SUBJECT: INITIAL EXAMINATION REPORT NO. 50-156/OL-04-01, UNIVERSITY OF WISCONSIN

Facility Comments Regarding NRC Exam Administered on March 15, 2004

OPERATOR LICENSING EXAMINATION
March, 2004

QUESTION A.19[1.0 point]

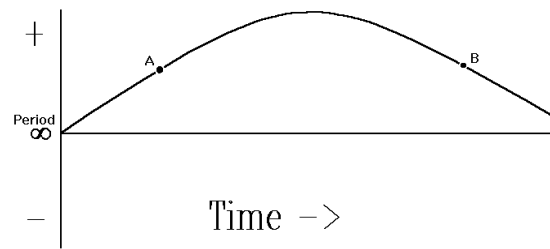
Question A.19

Facility Comment: No answer was provided in the answer key. The correct answer should be C.

NRC Resolution: Agree with comment. The answer key has been modified to show C as the correct answer to question A.19.

A.19 c. Answer added per facility comment (TYPO).
